# Agenda for 95<sup>th</sup> PCC Meeting

### **AGENDA FOR 95<sup>TH</sup> PROTECTION SUB-COMMITTEE MEETING TO BE HELD ON 15.10.2020 AT 10:30 HOURS**

### Report on the grid event in Eastern Region (पूर्वी क्षेत्र में ग्रिड घटना पर रिपोर्ट)

Figure 5: Status of the network of affected area after event 1

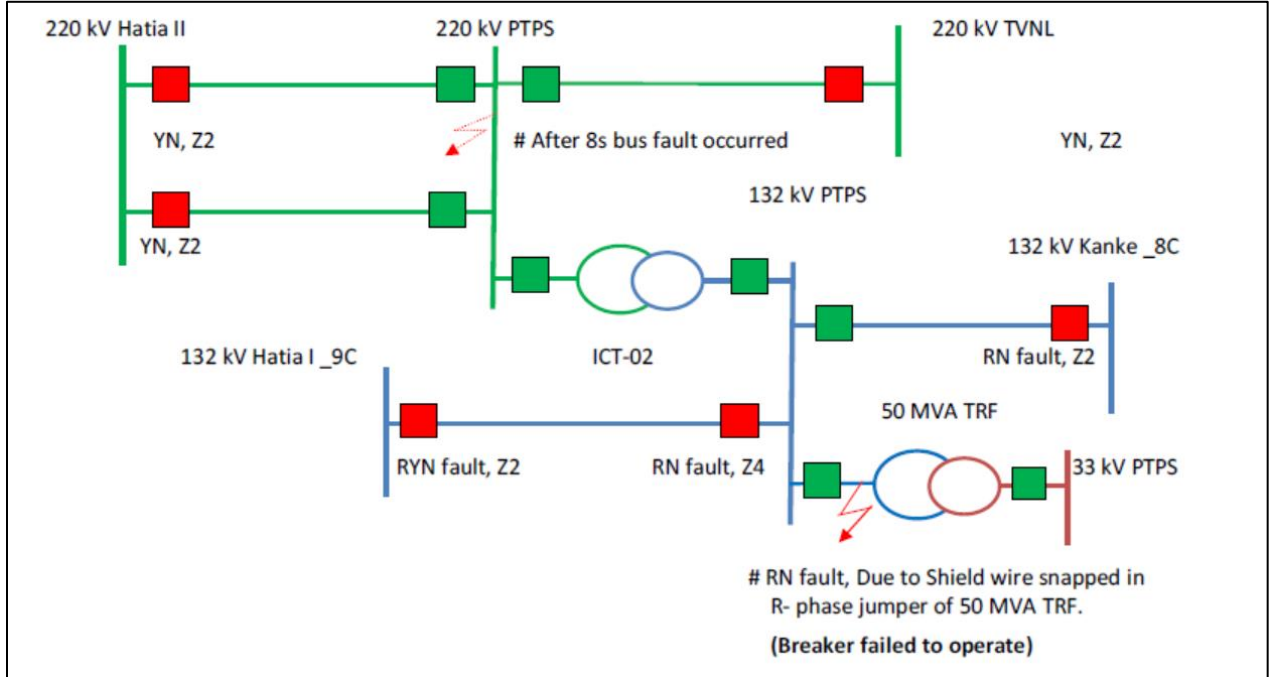
- At 08:45 hrs R phase to earth fault occurred at Patratu S/S due to snapping of the shield wire on 132 kV side R – Phase jumper of 50 MVA, 132/33 kV ICT. Differential & REF (field CT is used for Diff & REF) protection of affected ICT sensed the fault and issued trip command instantly to the breaker. But the breaker failed to operate due to the problem in its mechanism. The air pressure lock mechanism was found in the open condition during the investigation.

- There was no LBB protection available for the 132 kV side breaker at Patratu S/s. Kanke side relay of 132 kV Patratu – Kanke S/C (8C) sensed the fault in zone – 2 and tripped the line in from Kanke end.

- Hatia and Patratu side relay of 132 kV Patratu – Hatia S/C (9C) sensed the fault in Zone – 2 and Zone – 4 protection respectively and tripped breaker from Hatia and Patratu end in 480 ms and 580 ms respectively. **JUSNL may explain the reason for the tripping of the breaker at Patratu end of 132 kV Patratu – Hatia S/C as the line got already tripped from Hatia end. (Directional nature of distance protection may be checked by JUSNL)**

- 220/132 kV ICTs at Patratu S/s did not trip. So, the fault was being fed from 220 kV side via 220 kV Hatia Patratu D/C and 220 kV Tenughat Patratu S/C. Directional earth fault protection at Hatia end of 220 kV Hatia Patratu D/C sensed the fault. But the breaker did not trip as the fault current was below the pick-up setting (15% of 800/1). O/C and E/F protection of 220/132 kV ICT - 2 at Patratu failed to sense the fault. **JUSNL may share O/C and E/F protection setting of 220/132 kV ICT - 2 at Patratu.**

- Breaker of 50 MVA 132/33 kV ICT at Patratu failed to trip due to problem in the air pressure lock mechanism. JUSNL may share the remedial action taken after this event. The healthiness of the breaker at Patratu may be checked by JUSNL. **(JUSNL to update)**

- JUSNL may share O/C and E/F protection setting of 220/132 kV ICT - 2 at Patraru. JUSNL informed separate back up relay are not available for 220/132 kV ICT - 2 at Patraru. JUSNL may share the action plan for the installation of a separate backup relay. If the protection of this ICT acted properly total power failure at Patraru might have been avoided. **(JUSNL to update)**
- The directional setting of 220 kV Hatia – Patraru – D/C at Hatia end may be checked. Directional overcurrent protection operated at Hatia end for 220 kV Hatia – Patraru – 2 during event 2. Power was flowing towards Hatia at the time of the tripping. **(JUSNL to update)**
- The setting of DR output at Patraru station may be configured as per PCC's recommendation.

Figure 6: Status of the network of affected area after event 2

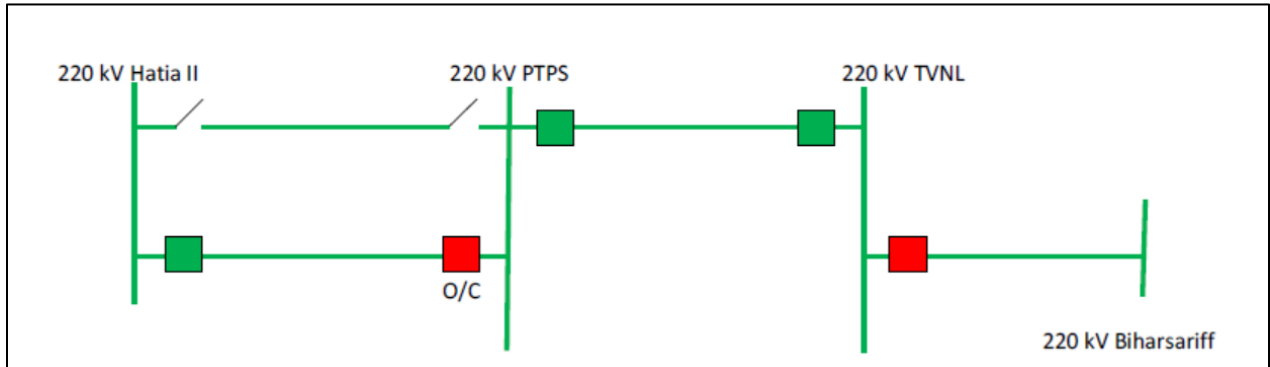
- During event 2, 220 kV Patratu – Hatia – 1 was not in service. At 13:49 hrs 220 KV Tenughat-Biharshariff S/C tripped due to B phase to earth fault at 106 km from Tenughat.

- After the tripping of 220 KV Tenughat-Biharshariff S/C, the whole generation of 220 kV Tenughat generating station was being evacuated through 220 kV Tenughat – Patratu S/C and 220 kV Patratu – Hatia – 2. As a result, Overcurrent protection operated at Hatia end. Current in all three phases at Hatia end for this line was around 600 A. Overcurrent protection setting was Pick up – 100%, TMS - 0.600 CT ratio -600/1. As per transmission planning criteria, the ampacity of 220 kV single zebra conductor is around 550 A for the maximum temperature at 75° C and ambient temperature at 45° C. Hence tripping of power flow through 220 kV Patratu – Hatia – 2 was more than its thermal limit prior to the tripping. **JUSNL may check the directional setting of this line at Hatia end.** As power was flowing towards Hatia, the line should not trip from Hatia end.

- Prior to the event 2, N-1 criteria did not satisfy for the tripping of 220 kV Tenughat – Biharshariff S/C. Therefore, tripping of 220 kV Tenughat – Biharshariff S/C resulted in power flow through 220 kV Patratu – Hatia – 2 more than its thermal capacity. Reduction of generation at Tenughat after event 1 (as circuit 1 could not be restored) might prevent the occurrence of event 2. **(Jharkhand SLDC to study and share their views)**
- No sequence of events has been recorded at ERLDC SCADA data at the time of the event. **(Jharkhand SLDC, TVNL, PTPS to update).**

Figure 1: Network across the affected area

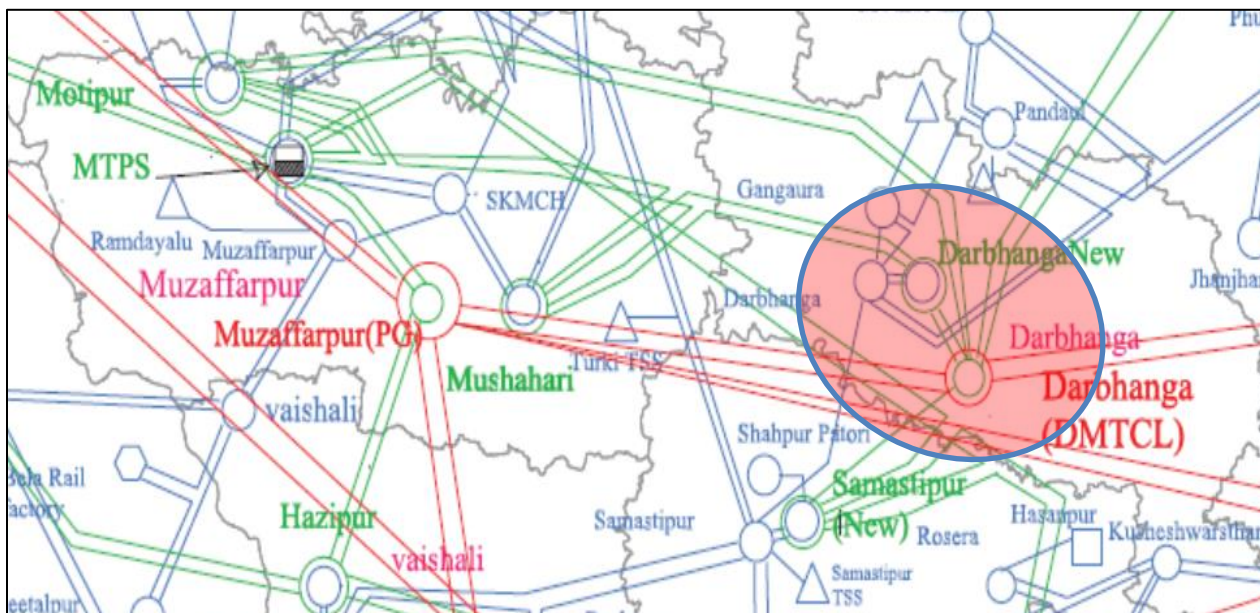
- At 16:27 hrs, 220 kV Darbhanga (DMTCL)-Darbhanga (Bihar)-2 tripped from DMTCL end due to operation of B phase Back up overcurrent protection (DR only showing pickup). At the same time, 400/220 kV 500 MVA ICT 1 & 2 at Darbhanga (DMTCL) tripped due to the operation of overcurrent and earth fault protection from 400 kV side. 220 kV Darbhanga-Mushahari-D/C tripped at the same time from Mushahari end due to distance protection. In addition, 220 kV Darbhanga(DMTCL)-Motipr D/C, 220 kV Darbhanga(DMTCL)-Samastipur 1, 220 kV Darbhanga (DMTCL)-Laukhai 1 has also tripped however the tripping details reason has not been shared.

- TBC breaker tripped at Darbhanga (BSPTCL) S/S on earth fault protection. BSPTCL informed that DR output could not be retrieved for this tripping incident due to the non-availability of the DR facility in TBC Relay which is Eassun MIT 114. BSPTCL has shared that they would replace all old relays with numerical relays having DR/EL facility. **(BSPTCL may share the timelines for replacing the old relays.)**

- During the field investigation BPI of Y-phase of TBC at Darbhanga (BSPTCL) was found flashed at Darbhanga BSPTCL S/S. The IR value of BPI in all three phases was checked during the investigation and found unsatisfactory. BSPTCL has intimated that they have planned to replace all BPIs. **(BSPTCL may share the timelines for replacement works. BSPTCL may also share the status of the bus bar protection system at Darbhanga (BSPTCL) GIS.)**

- As per the DR recorded at DMTCL end for 220 kV Darbhanga – Darbhanga – 2, There was y phase fault (Fault current: 8.7 kA). The fault was cleared within 100 ms with tripping of all the three poles of the beraker and outage of circuit from Darbhnaga (DMTCL) S/s. DR also shows that from Darbhnaga (BSPTCL) S/s the breaker has not tripped as voltage in faulty phase as well as healthy phases persisted for around 500 ms. From the DR/EL , it is not clear on which protection Darbhanga (DMTCL) end breaker had initiated the trip command. The DR/EL file of Darbhanga (DMTCL)end needs further improvement. Digital channel flag shows single phase tripping however all the three phases have tripped is also not clear. DMTCL (Darbhanga) may clarify the event.

- As per DR recorded for tripping of ICT-1 at DMTCL, tripping command for directional earth fault was given within 150 ms. **DMTCL may check the time setting of directional earth fault protection of both ICTs. Such immediate tripping indicates higher setting of ICTs encroaching the next voltage level.**

- Why the bus bar protection has not operated for this fault at Bihar (BSPTCL) end. Whether any bus bar protection is in service at the substation may be clarified by BSPTCL. **(BSPTCL to update)**

- All breakers in Darbhanga (BSPTCL) are required to be tested starting from the initiation of trip command from the relay to tripping of breaker poles. A detailed protection audit and protection review of all substations (BSPTCL) in that area also is required to be carried out by BSPTCL in coordination with DMTCL. **(BSPTCL to update)**

- Time setting of Directional Earth Fault relays of 400/220 kV ICTs at Darbhanga (DMTCL) may be checked. **(DMTCL to update)**
- DR/EL configuration may be properly checked and configured at DMTCL end as per the issues observed in event analysis. **(DMTCL to update)**

- BSPTCL may share the timelines for replacement works of BPI and installation of numerical relays at Darbhanga (BSPTCL). BSPTCL may share the status of bus bar protection at Darbhanga (BSPTCL) end. **(Bihar SLDC/BSPTCL to update).**
